SUBJECT: CERTIFICATION OF THE POWER UPRATE SUBCOMMITTEE  
MEETING MINUTES ON APRIL 23, 2010

SUBJECT: THE MINUTES OF THE POWER UPRATE SUBCOMMITTEE  
MEETING ON APRIL 23, 2010 IN ROCKVILLE, MD

ADVISORY COMMITTEE ON REACTOR SAFEGUARDS  
POWER UPRATE SUBCOMMITTEE MEETING MINUTES  
APRIL 23, 2010, ROCKVILLE, MD

Slide 18

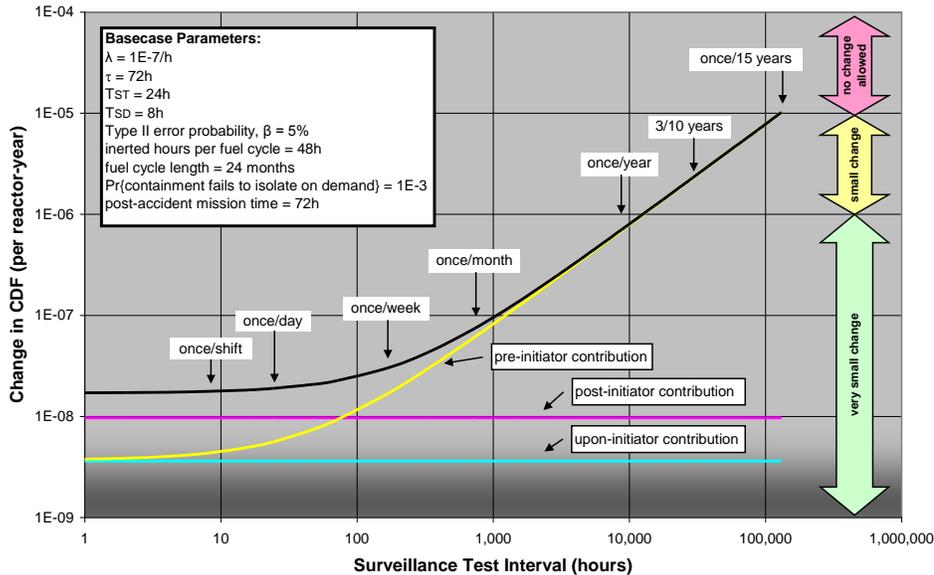
Discussing Slide 18, Mr. Stutzke stated that there are some insights that can be ferreted out risk evaluation.

- Surveillance testing more than one week doesn't really effect the delta CDF because it goes up asymptotically horizontally flat. However, if you have longer surveillance test intervals around the integrated leak rate testing time of three in ten year or once in 15 years and that is the only way containment integrity can be confirmed, the change in risk is unacceptably high.
- One accident sequence that contributes directly to core damage frequency is large break LOCA sequence. All the other scenarios would require multiple failures.

**Typical Relative Erosion Rate vs. NPSH Margin near BEP Flow Rate**  
Slide 18 (Cavitation Acoustic Signal)

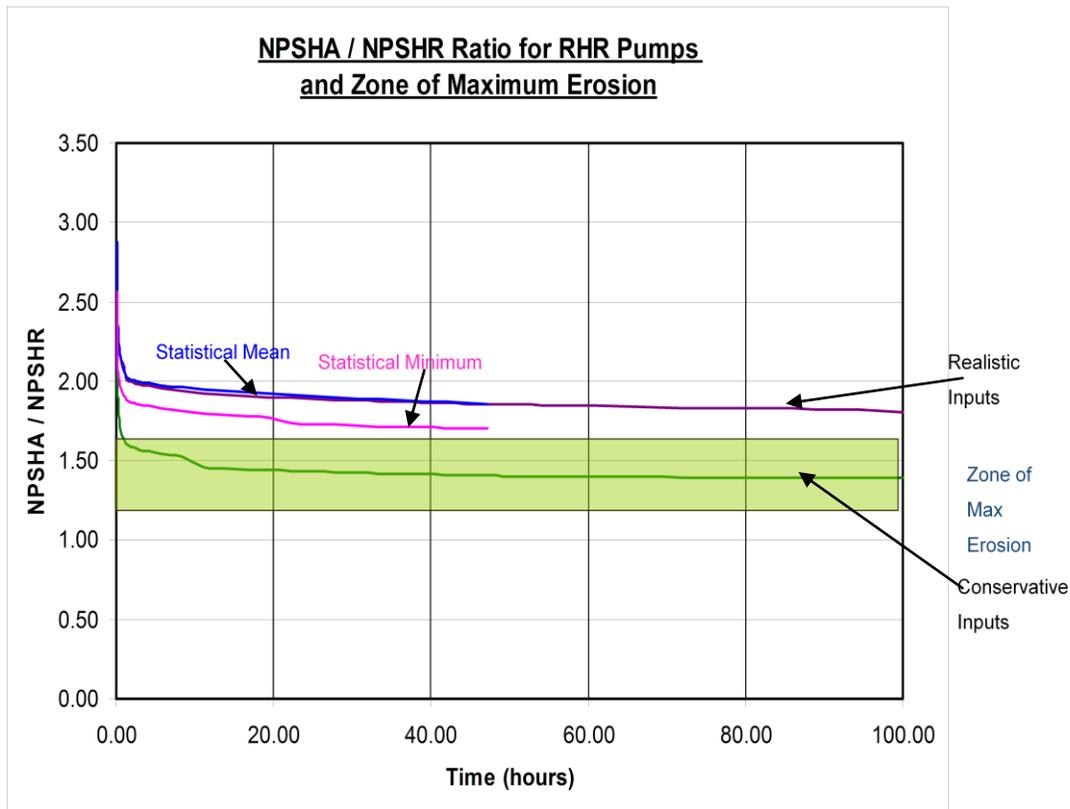
One way to measure the amount of cavitation is with acoustic measurements. Pressure transducers or other acoustic transducers on the pump suction measure the cavitation noise that comes from the imploding bubbles. He noted that this is the relative noise that is stated in terms of cavitation, erosion rate, but it is really a measurement of cavitation noise as a function of the NPSH margin ratio which is the available to the required. When the value is high, the noise is relatively low. As margin is lowered, as the available NPSH goes down, the noise increases until you reach a peak, then the peak starts to decrease again. That (*reasons for the decrease in noise*) is due to the vapor bubbles and due to the air that is coming out of solution in the water. Mr. Lobel described how they came up with the erosion range, stating that the staff took this curve (See Slide 18) to a typical curve and picked a high and a low boundary to this curve that captured the peak and said that was the result of maximum erosion. Under member questioning on how to establish points B or C, in terms of 3% NPSH required, Mr. Lobel referred to Slide19 (shown below).

**Slide 36**

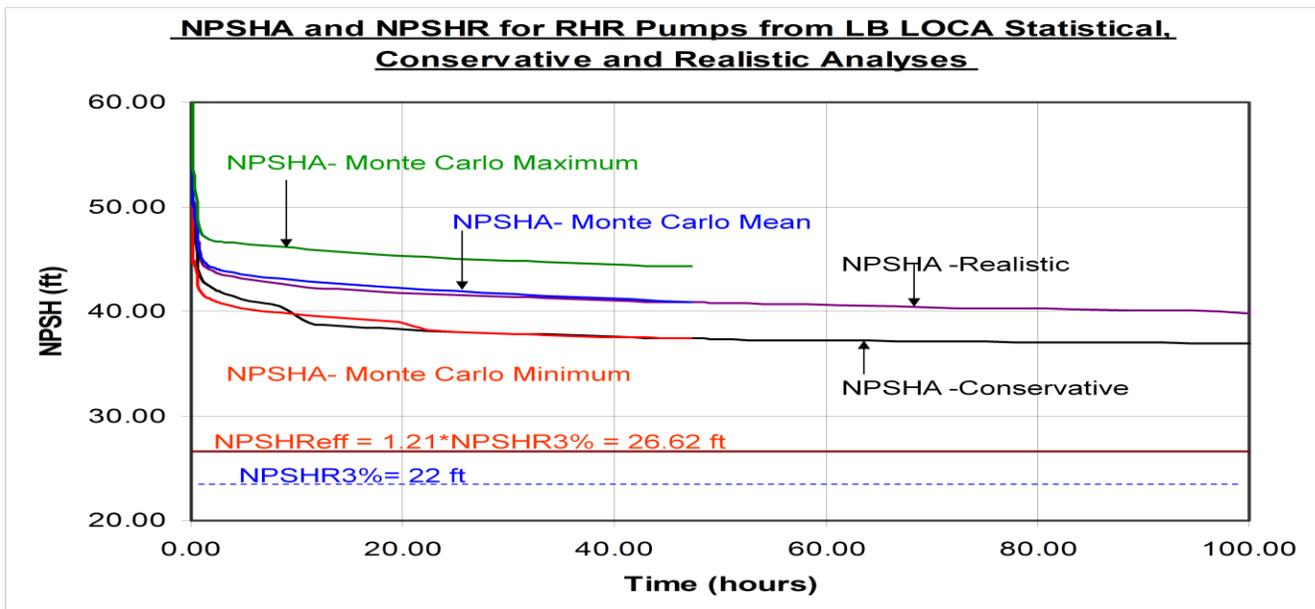
Mr. Lobel remarked that the Committee had asked several times how important were the different parameters (that factor into the NPSH calculations). The staff performed sensitivity analysis for one typical BWR/4, with the Mark I containment. Slide 36 lists all the variables that the staff thought contributed to the NPSHA calculation significantly. For the sixteen input parameters, the staff changed each single input parameter from the base case by 5%. The table (below) provides the corresponding percentage change in the suppression pool temperature, wetwell pressure, and NPSHA. The staff also performed three additional calculations that: (1) changed the decay heat sigma value from 2-sigma to 0-sigma; (2) increased the containment leakage increased from  $L_a$  to  $5.0L_a$ ; (3) performed calculations with and without heat sinks was performed; and (4) changed the heat transfer coefficient options in the GOTHIC code from empirical correlations to the heat and mass transfer analogy (DLM). Mr. Lobel discussed their assessment of the results of the sensitivity analyses, stating that they found the presence or absence of passive heat sinks to be significant. He added that the area of the passive heat sinks is less significant but important. The staff also found that the sensitivity to the condensation heat transfer coefficient is significant. The staff found the containment leakage rate not to be significant. He explained that the strainer and piping losses are not as significant as many other input variables. Mr. Lobel concluded that as

shown in the table (Slide 36), a relative large number of input variables have significant effect on the available NPSH.

In the staff's presentation of their conclusions of the NPSH available sensitivity analyses, Subcommittee Chair Shack commented that he found it strange that the sensitivity to the strainer and piping losses were insignificant. He said that he expected a five percent change to make a five percent change in the available head. Mr. Lobel explained that the strainer losses weren't very large and it is combined with the piping friction losses. Member Abdel-Khalik remarked that this (result) is all an artifact of the five percent variability that that was imposed because five percent change in power is a huge change. He added that whereas a five percent in the heat sink temperature in degrees F, because that is units dependent, is relatively small compared to the range that you expect to operate within. Mr. Lobel accepted the comment and stated the staff was open to suggestions of what the Subcommittee would like to see, because it is not hard to do.

**CAP Required for RHR Pumps During DBA LOCA**

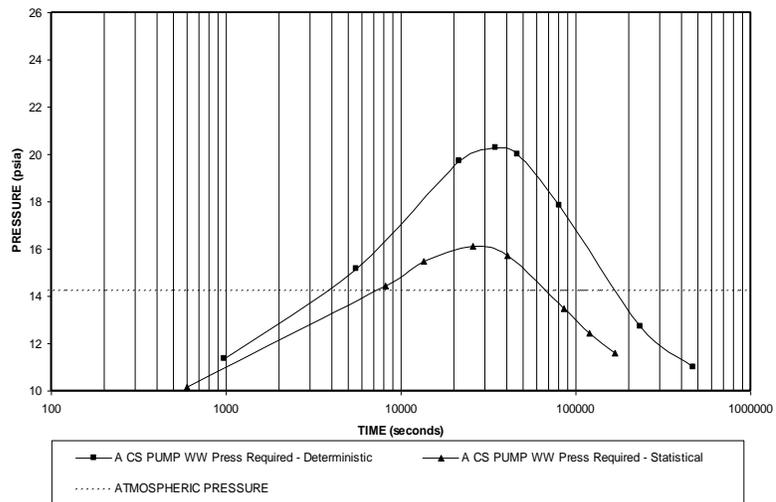
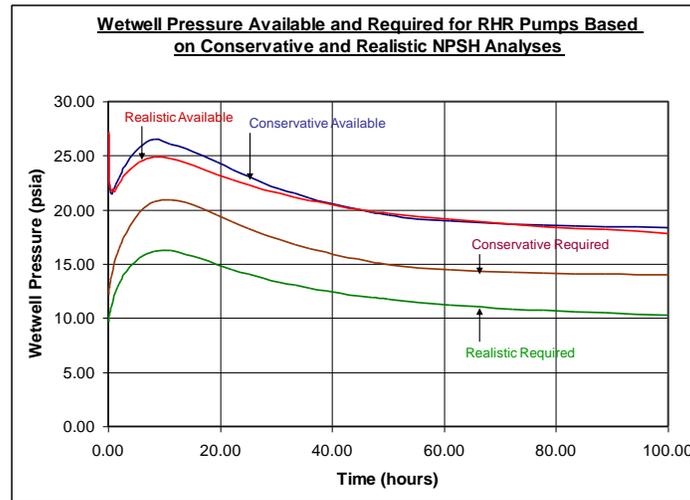
Member Abdel-Khalik added that this (BWROG's) graph shows that if you do the conservative calculation, you need a lot more containment over pressure to meet the criterion than you would if you were to use this 95/95 method, which means that there is a big difference between the two analyses.

Mr. Wojchowski (BWROG) intervened stating that in their presentation, for their deterministic calculations all of the values were put at bounding peak values and low values. The statistical was the 95/95 confidence level. He suggested that what the NRC was doing is their conservative value was realistic and then they added in some uncertainty to it. He proposed that the staff's conservative isn't really the same basis as the BWROG deterministic.

After more discussion, Subcommittee Chairman Shack stated that the staff needs to provide some comparisons of the same quantities. If BWROG is doing required, the staff also provides a plot of required. If staff is doing NPSH, the BWROG needs to provide a plot of NPSH. With this guidance for the upcoming full committee, the issue was closed.
